City of Ryde Local Planning Panel Meeting No. 6/20

| 1 | 68-70 Chatham Road, Denistone - New multi-dwelling housing containing four (4) dwellings - 2 x 2 storey, 3 and 4 bedroom dwellings at the front and 2 x single storey, 3 bedroom dwellings at the rear as well as strata subdivision - LDA2018/458..... | 3 |

City of Ryde Local Planning Panel Report

DA Number	LDA2018/458
Site Address & Ward	68-70 Chatham Road, Denistone NSW 2114 Lot 13 in Deposited Plan 9166 Lot 14 in Deposited Plan 9166 West Ward
Zoning	R2 Low Density Residential
Proposal	New multi-dwelling housing containing four (4) dwellings - 2 x 2 storey, 3 and 4 bedroom dwellings at the front and 2 x single storey, 3 bedroom dwellings at the rear as well as strata subdivision.
Property Owners	Kwong Fah Chong, Yuen Yee Poon, and Siew Loon Poon
Applicant	Wen Architects C/O: Hao Yan
Report Author	Simon Truong, Consultant Planner
Lodgement Date	3 December 2018
No. of Submissions	110 submissions received, all objecting to the proposed development.
Cost of Works	\$1,385,428.00
Reason for Referral to LPP	Contentious development – (b) in any other case

Figure 16: Extract of ground floor plans showing internal privacy impacts
Source: Architectural plans

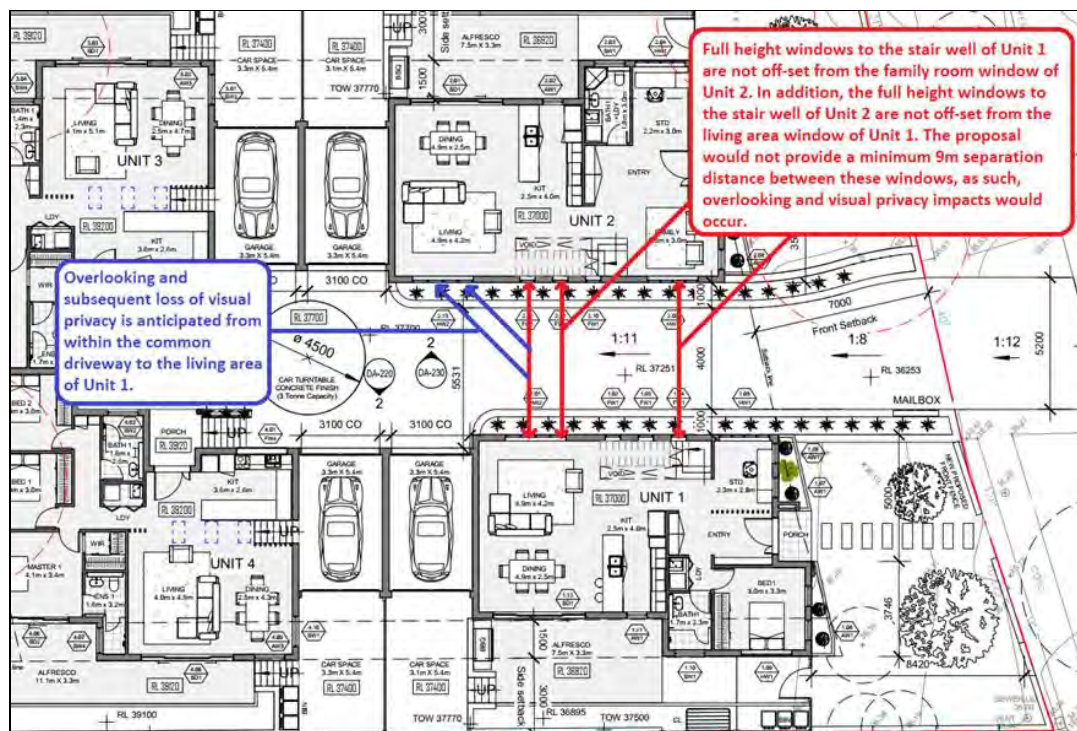
The stairs of Dwelling 1 and 2 have direct views into the respective living and family rooms. Further the sill height of the living room windows of Dwelling 2 is less than 1.5 metres high and this window faces onto the common driveway. The above will result in unacceptable privacy impacts between dwellings (**Figure 16**).

Additionally, the excessive cut and fill arrangements result in poor design outcomes when trying to limit overlooking to adjoining properties. For example, in order to maintain visual privacy, a 1.8 metre boundary fence on top of a 1.12 metres high retaining wall is proposed along the southern boundary of Unit 4. This adversely impacts on the visual outlook of No. 66 Chatham Road whereby a boundary fence height of up to almost 3 metres is provided at the private open space of No. 66 Chatham Road. Alternatively, if an overall fence height of 1.8 metres was utilised (when measured from EGL at No. 66 Chatham Road), this would result in direct overlooking into the rear private open space of No. 66 Chatham Road given the raised deck and ground floor level of Unit 4. This poor design outcome is a direct result of the site's unsuitability for multi dwelling housing because of the gradient, and the poor design response to the site constraints.

Figure 17: Extract of Tree removal and retention plan

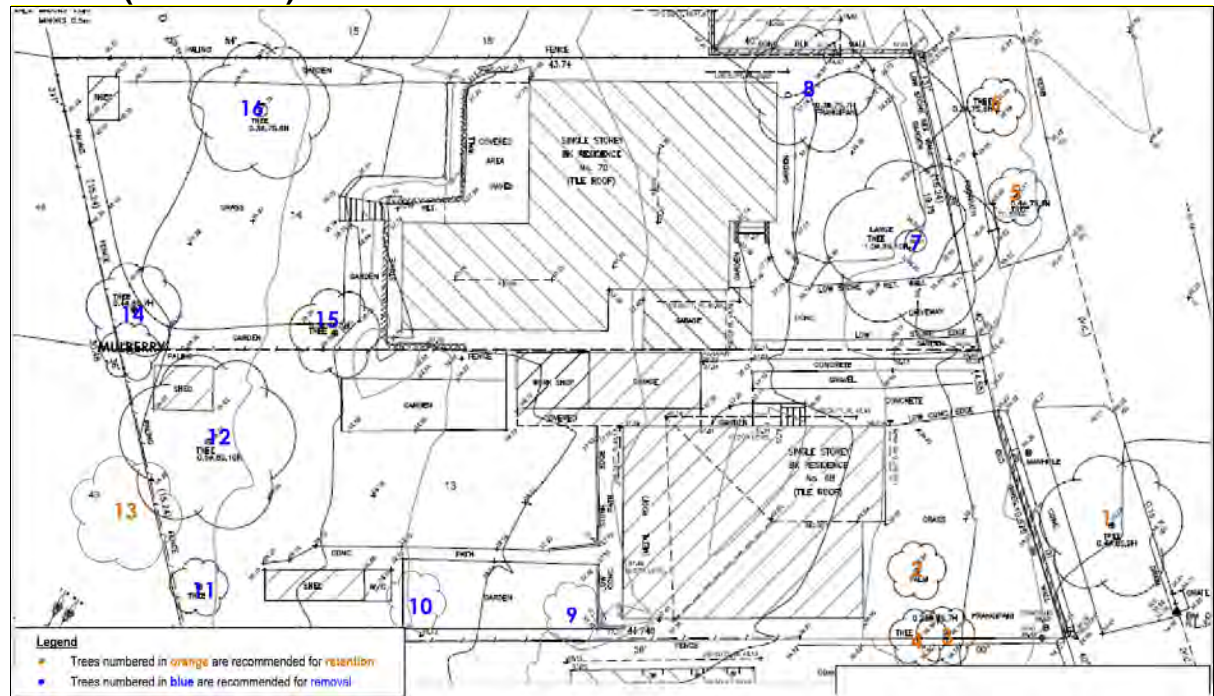
- The proposed removal of nine (9) trees (Trees 7, 8, 9, 10, 11, 12, 14, 15 and 16) is supported as they are not considered capable of being retained due to the unacceptable and unavoidable impacts from the proposed construction works. The removal of these trees will result in a low to moderate impact to the landscape character of the subject site and replacement planting is required.
- The retention of three (3) trees on site (Trees 2, 3 and 4) is supported. The retention of three (3) Council street trees (Trees 1, 5 and 6) will require referral and approval from Council's Tree Management Team prior to any consent being granted. However, given their location away from the proposed construction works, they are unlikely to be impacted.
